**#2010-51**

**Chase Bank – 1185 S. Route 31 Lutter Center  
Project Review for Planning and Zoning Commission**

**Meeting Dates:** September 1, 2010 and September 15, 2010

**Location:** 1185 South Route 31 (Lutter Center)

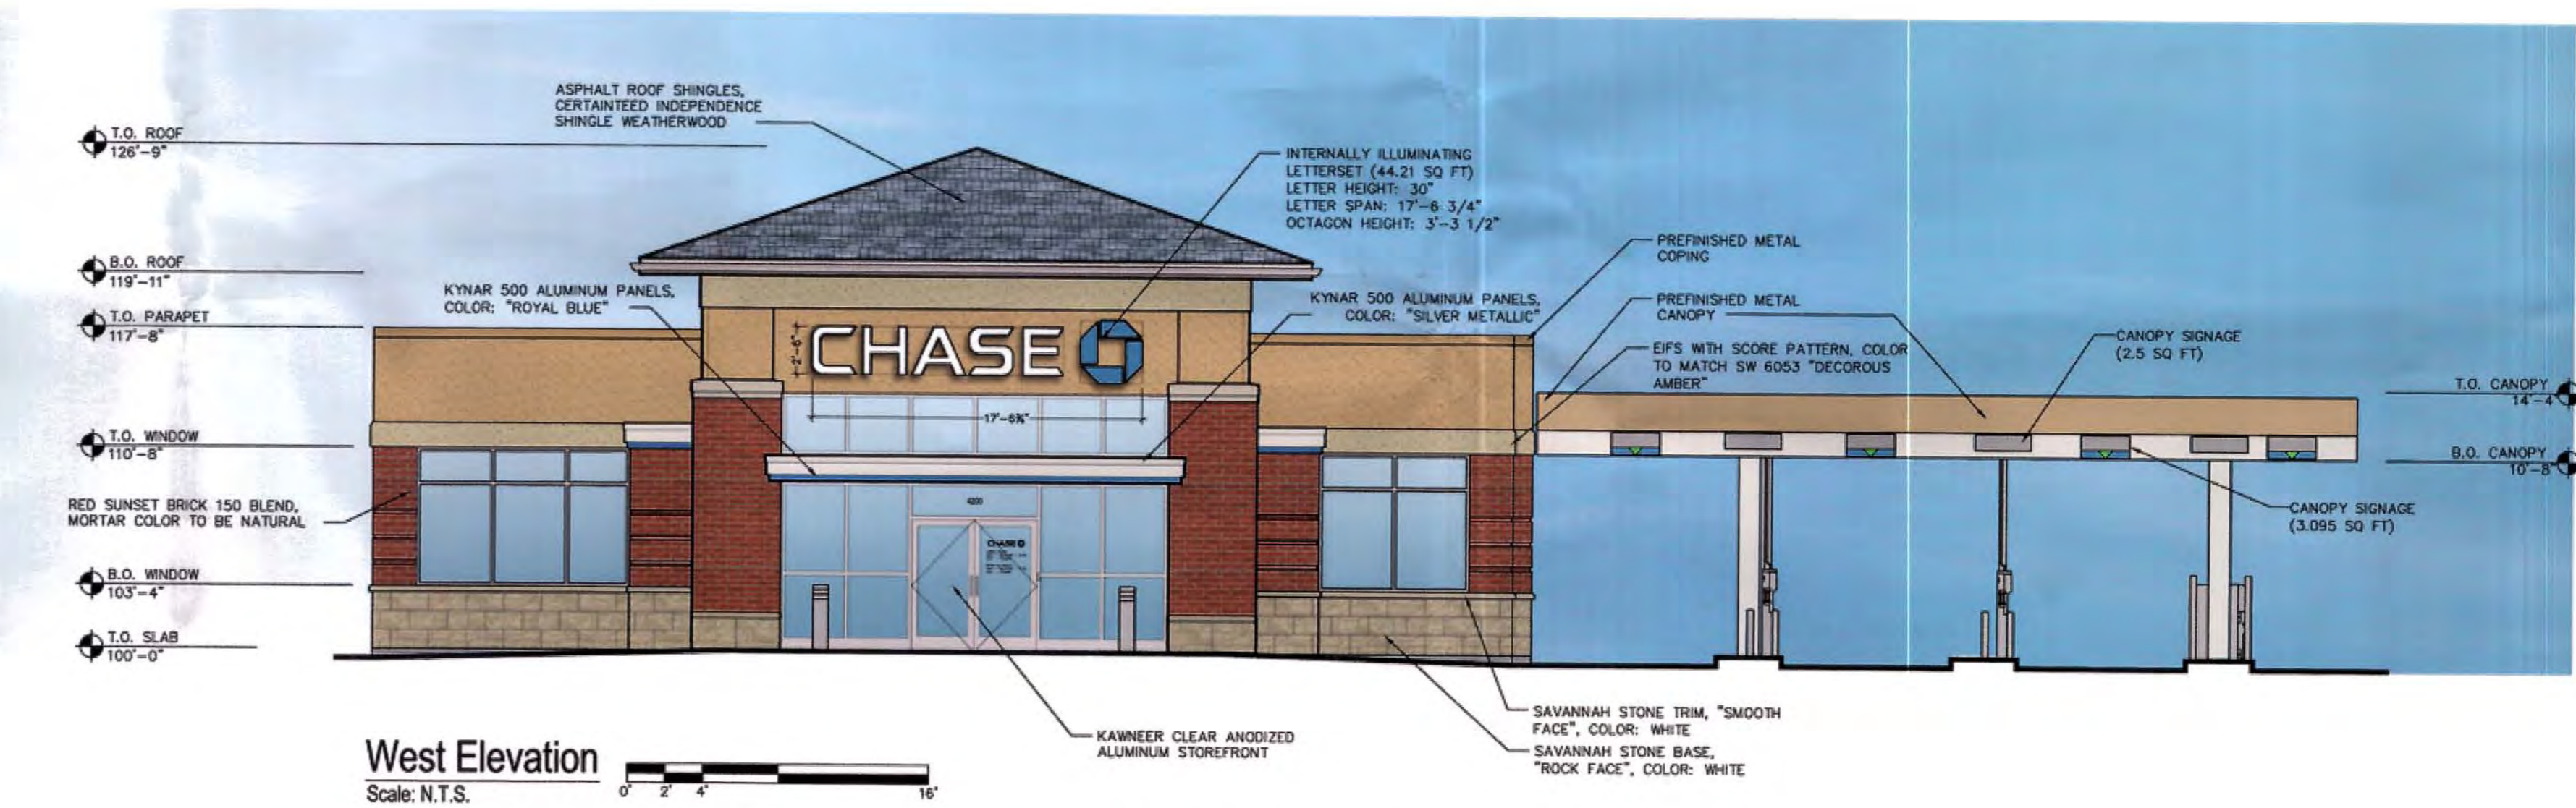
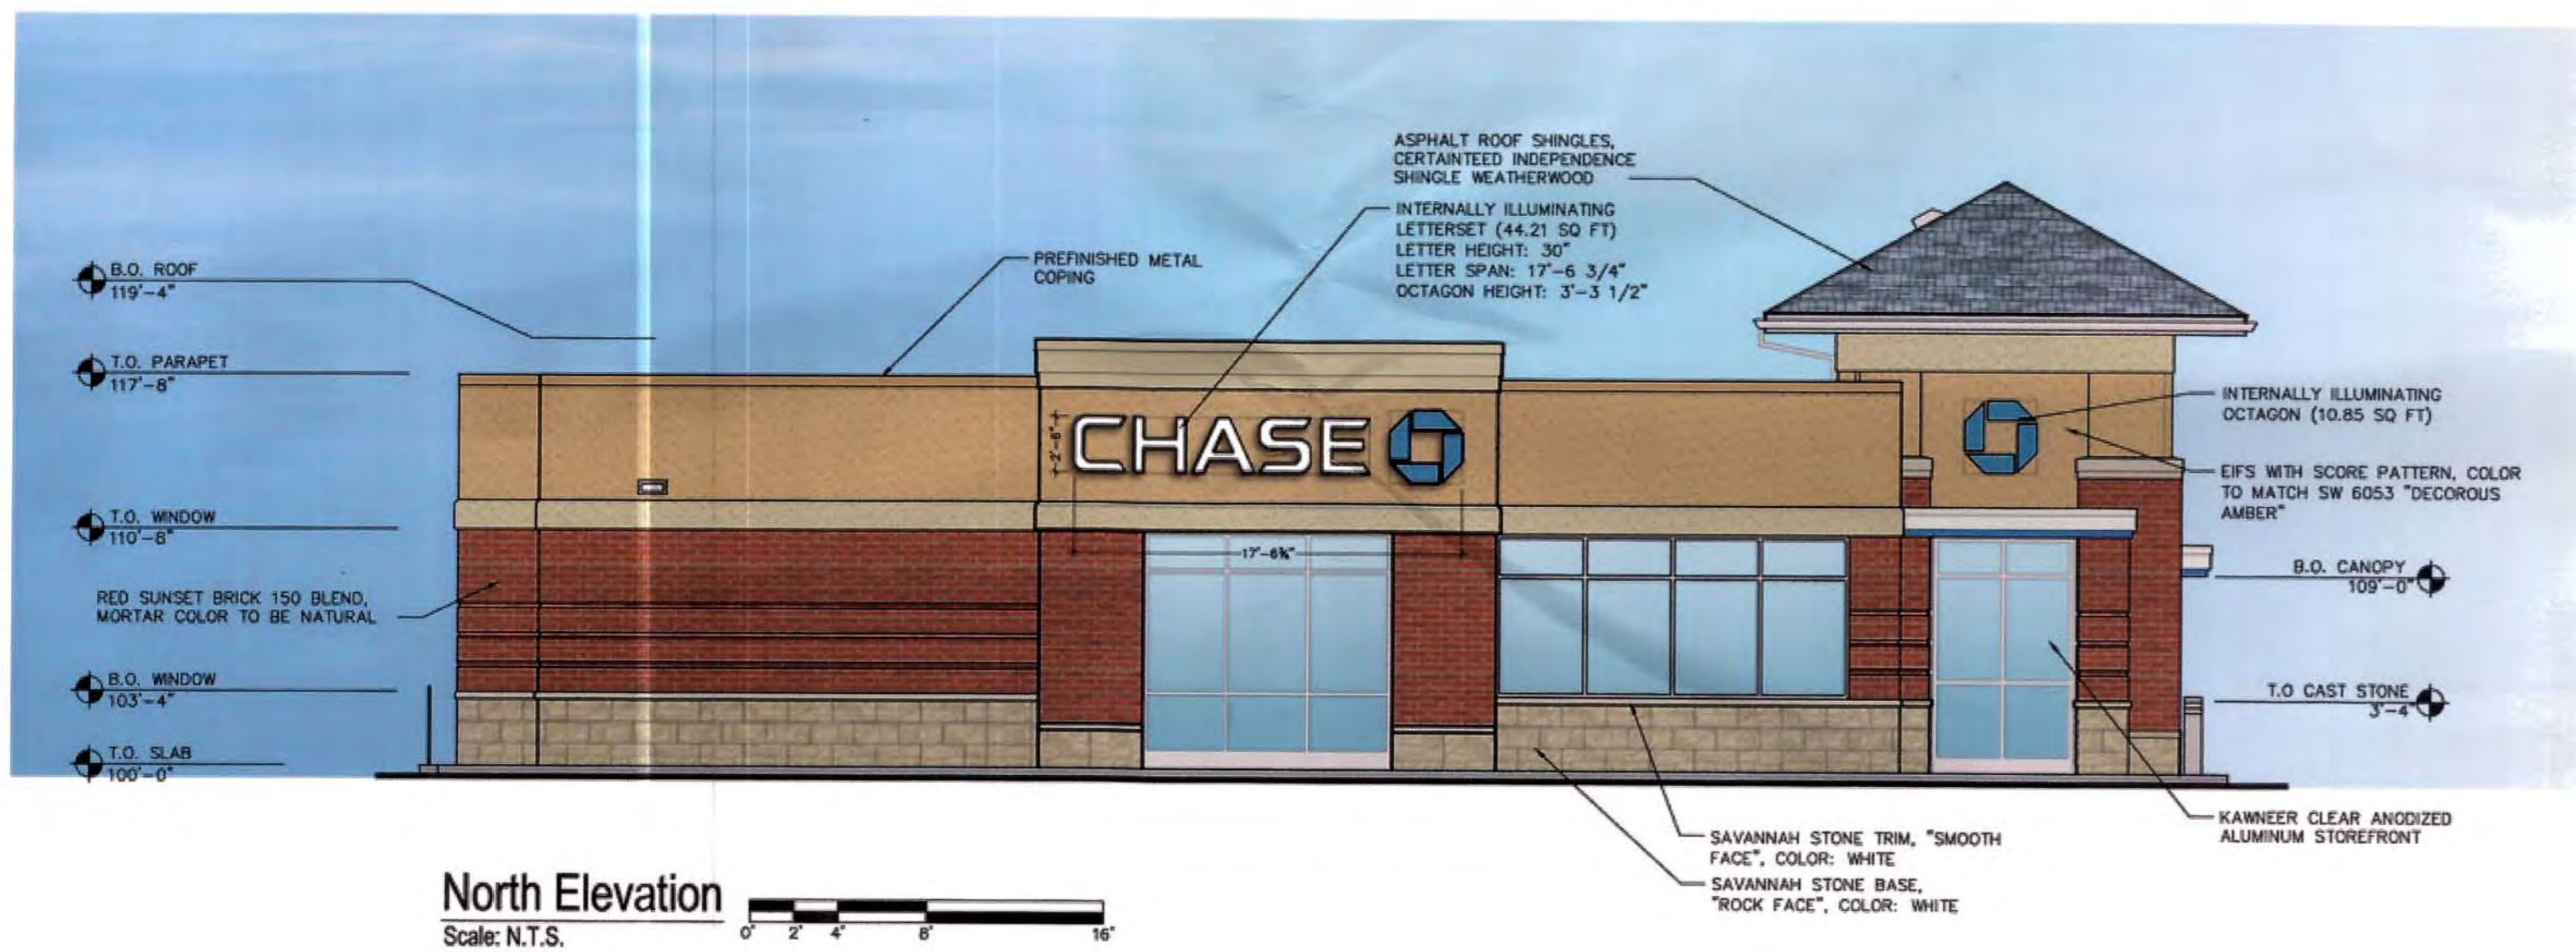
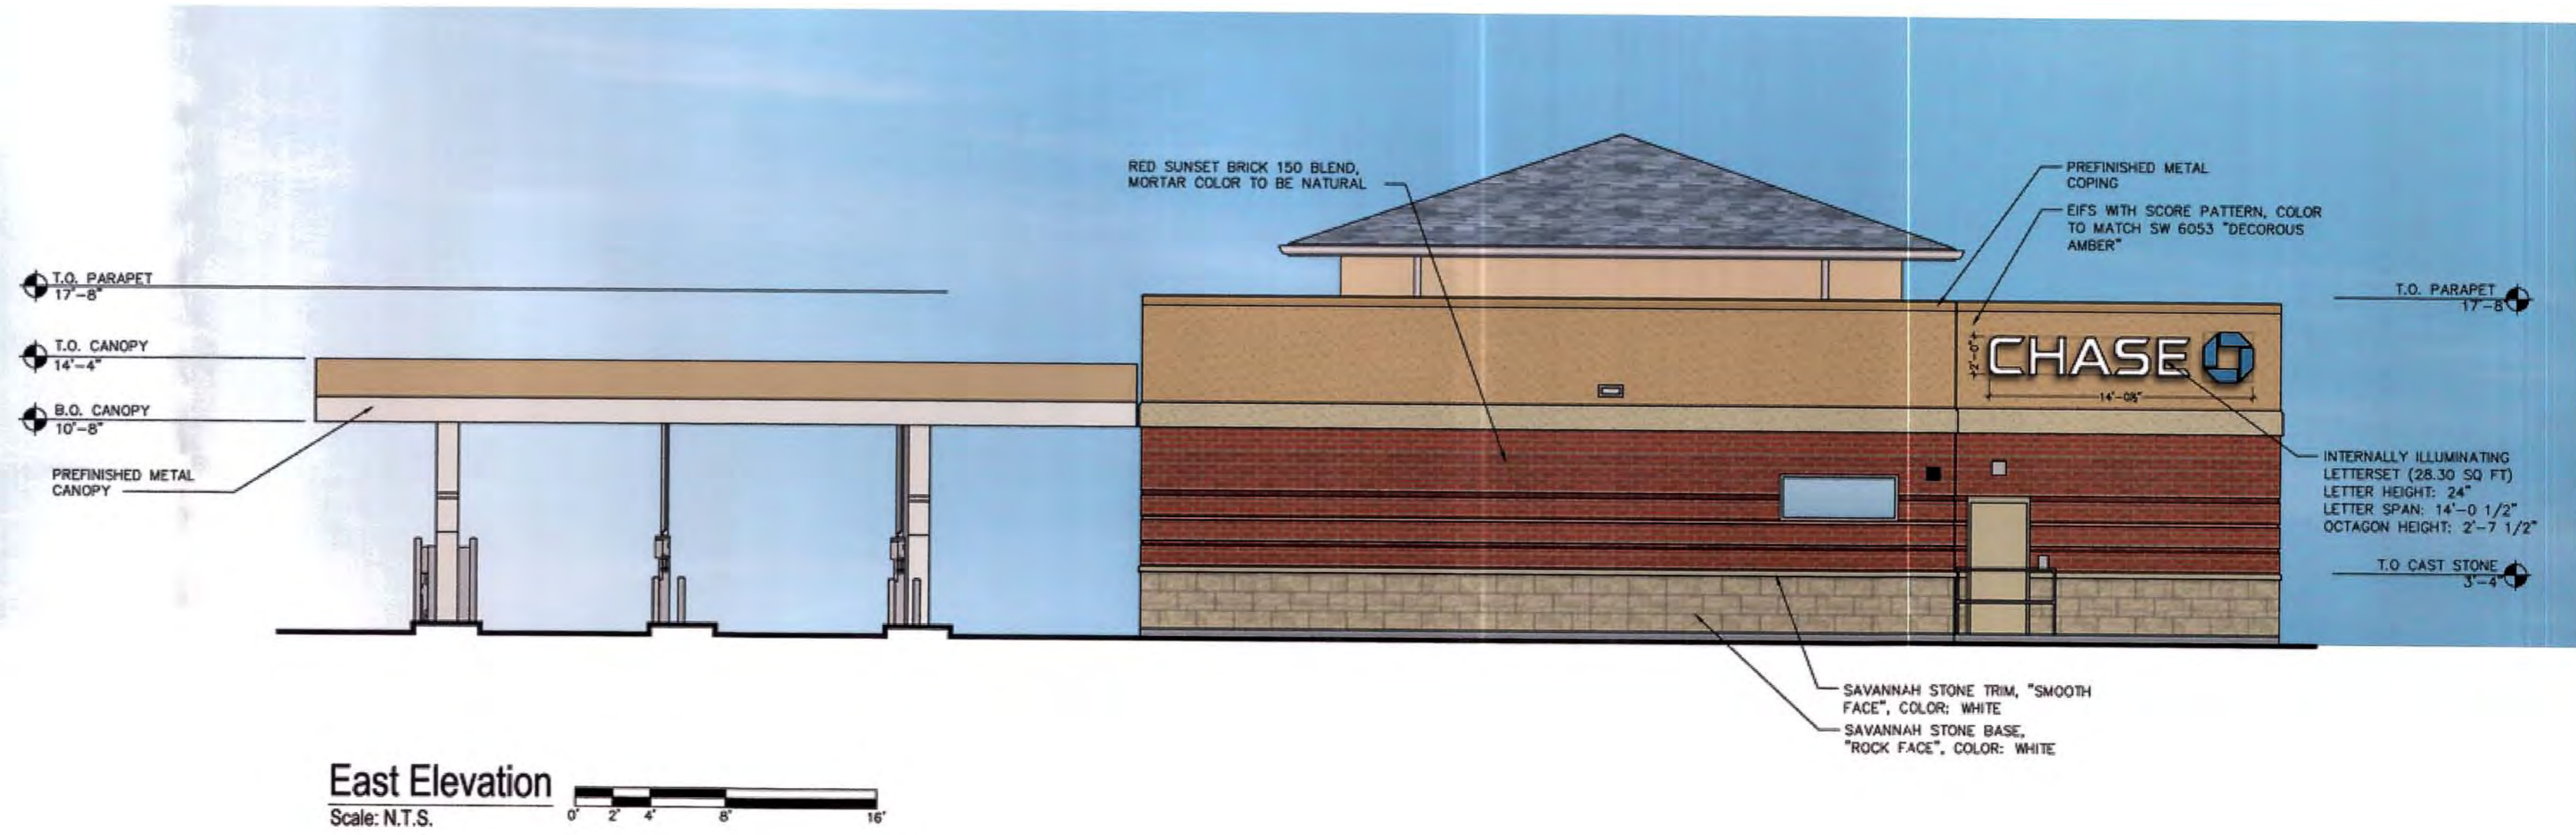
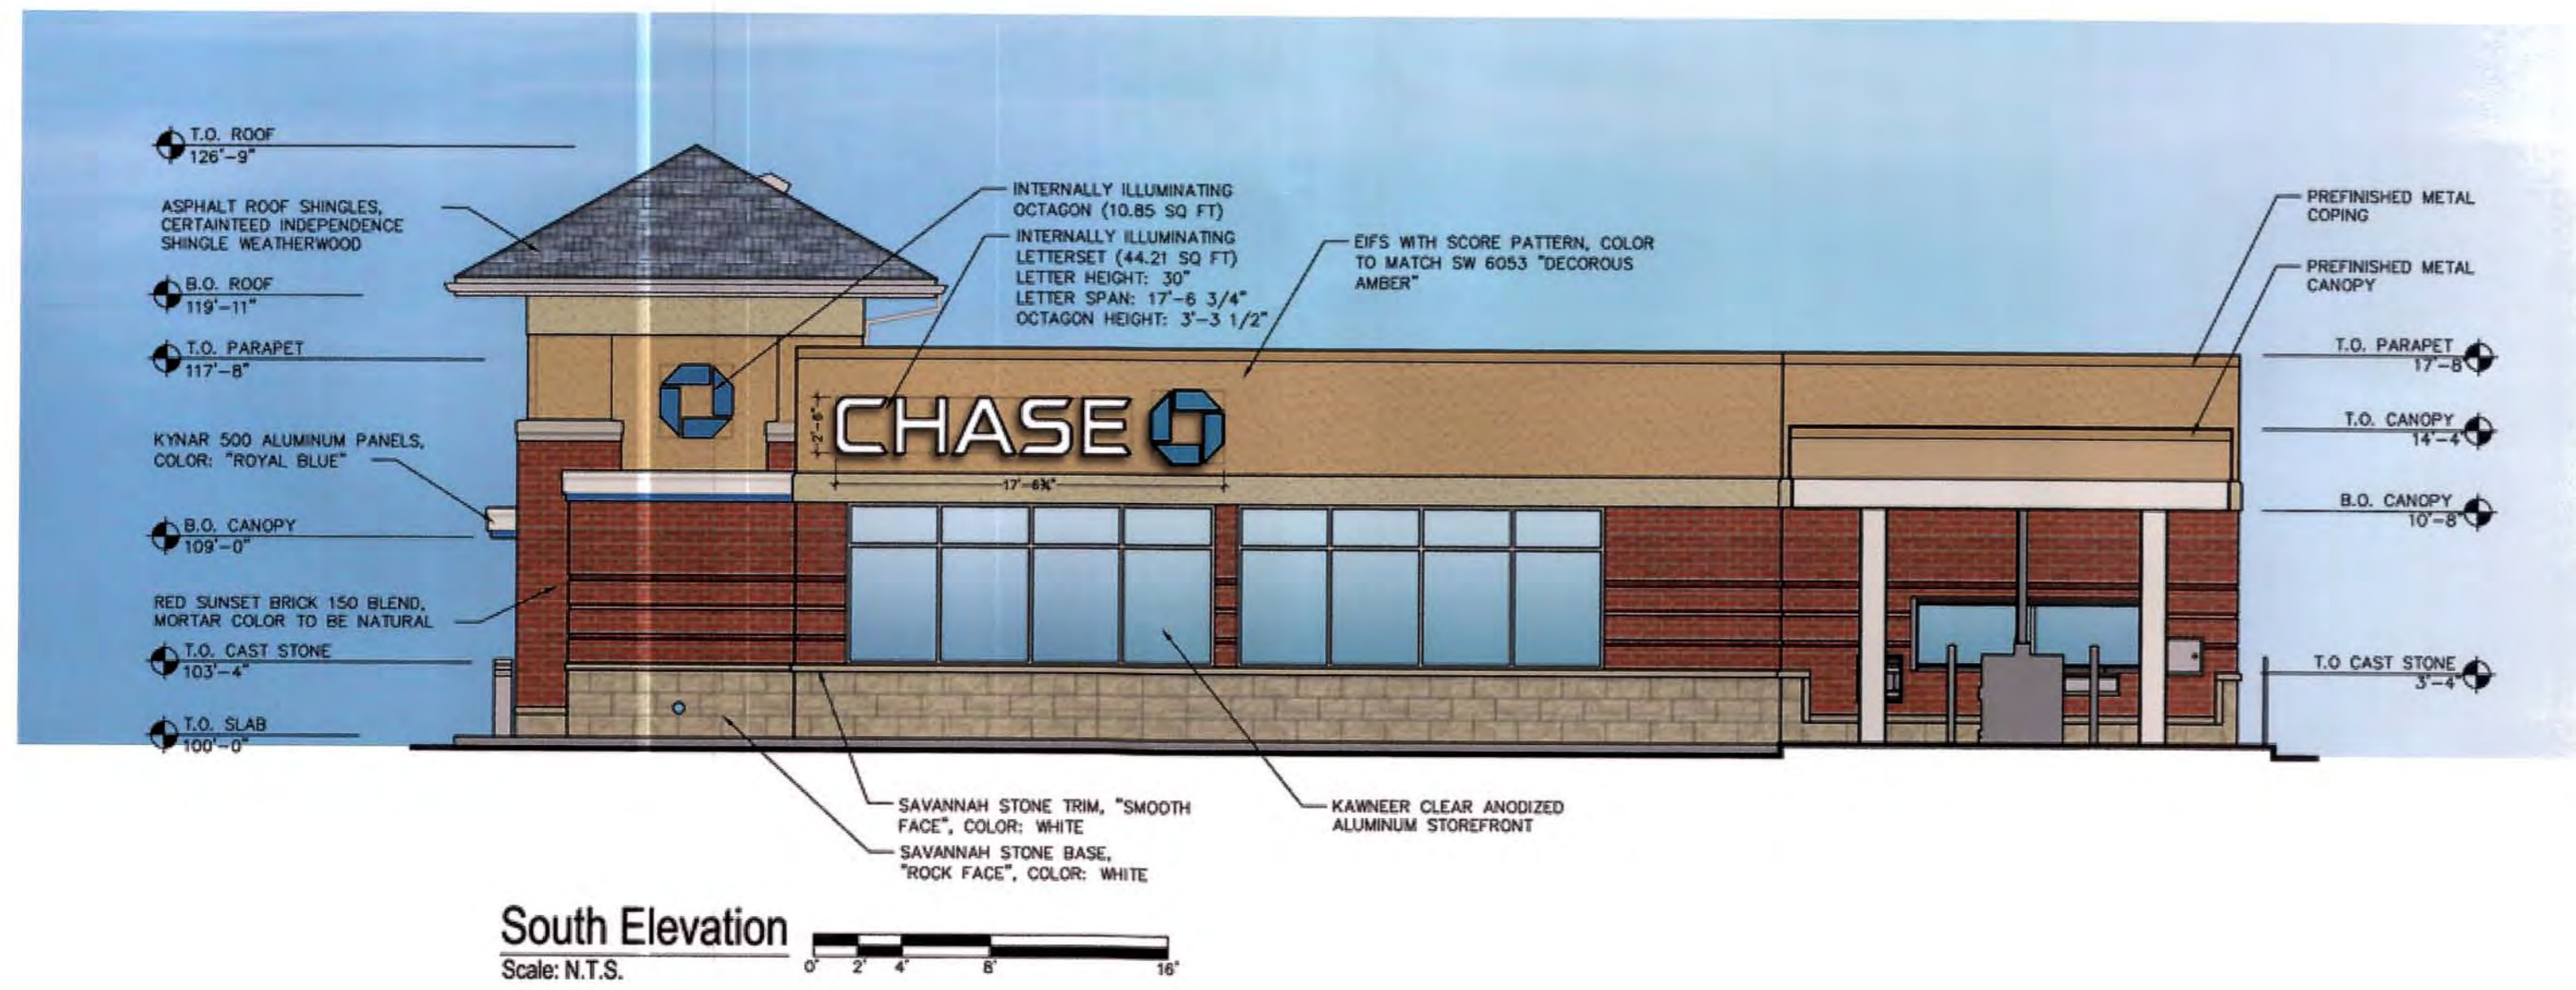
The building is designed with a CMU base, brick main wall area and EIFS top portion. The building has a flat roof with a peaked roof above the front center portion of the building. This building is adjacent to the Central Park inline retail buildings and the Wal-Mart Supercenter. Wal-Mart selected Sand and Cream for their EIFS colors with Promenade Blend for the brick and a deep brown colored CMU. Chase Bank is selecting White CMU for the base, Red Sunset colored bricks and Decorous Amber as the EIFS color. Material samples are required to ensure that the Chase Bank color selections will blend well with the Wal-Mart center appearance.

Since this lot is the gateway to the City, a high quality of architecture is required. Both the Central Park inline retail buildings and the Wal-Mart have column elements. The Chase Bank building should also create more defined column elements. Additional architectural elements or details should be added to the drive-through canopy so it is better integrated with the building's architecture. The window bays shall be recessed or have larger headers and sills to provide additional detail around them.

The signage requested is 202.51 square feet and includes the main Chase sign and logos as well as the signage on the drive-through canopy. Stand-alone buildings are permitted up to 150 total square feet of building signage. Chase is requesting a 52.51 square foot variation. Chase is proposing a 4-foot wide 24-foot tall free-standing sign. The UDO permits signs for office tenants to be 5-feet high and 32 square feet. This is a variation of 19 feet in height and 67 square feet. All proposed signage should meet the UDO requirements.

4. Architecture
  - A. Material samples shall be presented to the Planning and Zoning Commission and City Council and shall resemble the current Wal-Mart colors and materials.

- B. The window bays shall be recessed into the elevation to provide additional relief and interest to the elevation. If they cannot be recessed larger headers and sills shall be incorporated around the window and door openings to provide the architectural details.

- C. An additional top element shall be added to the drive-through canopy to finish off the canopy and provide integration with the building elevations.

- D. Column features shall be added around all four sides of the building to emulate the Wal-Mart center.
  - E. The rear man door shall be a 6-panel decorative door.

5. Signage
  - A. The building wall signage shall be reduced in square footage to meet the total of 150 square feet of signage.
  - B. No signage shall be placed on the drive-up ATM machine with the exception of any legally required or instructional signage.
